**GOVERNMENT OF THE DISTRICT OF COLUMBIA
DEPARTMENT OF TRANSPORTATION**

MEMORANDUM

SUBJECT: ZC Case No. 14-21 – 907 Barry Place NW – Barry Place PUD

Figure 1 Site Design and Access (Source: Niles Bolton)

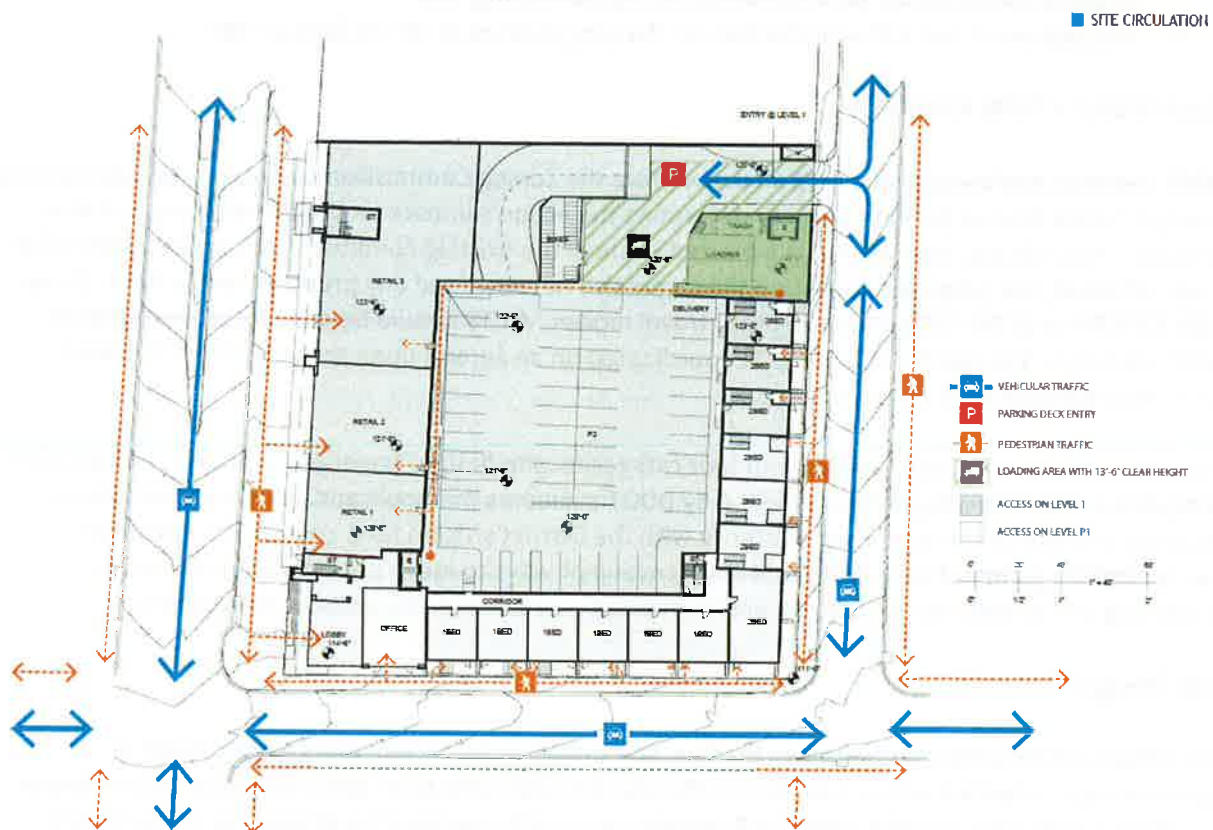
This Site is bounded by Sherman Avenue on the west, Barry Place on the south, and 9th Street and the east. Under a separate process, the Applicant pursued and received permission to close an existing alley that ran through the site. Vehicle, loading, and trash access is proposed via a single curb cut on 9th Street and trucks are able to access the site without backing maneuvers in public space, and is in keeping with DDOT's approach to site access.

The primary pedestrian access points for the residential and retail uses are from Sherman Avenue, which has the most generous sidewalk widths of all the streets adjacent to the property

- Since trucks backing into the loading facility will block access to/from the parking garage, flaggers positioned within the garage must be utilized when loading to ensure that vehicles entering and exiting the garage can do so safely and without queuing onto 9th Street.

Preliminary public space plans show utility vaults in the public space along Sherman Avenue. DDOT's approach to utility vaults is to allow vaults in public space only when they cannot be located on private property. If in public space, vaults must be surrounded by landscaping to prevent people from walking on them and to shield the vaults from view. As currently proposed, the vaults are surrounded by landscaping on three of four sides. The Applicant will need to coordinate with DDOT on the vault location and treatment during the public space permitting process.

The preliminary public space plans show significant paving in the "public parking" zone on Sherman Avenue, which is an area meant to be a vegetated extension of the District's park system. The Applicant will be expected to include additional landscaping in this area.
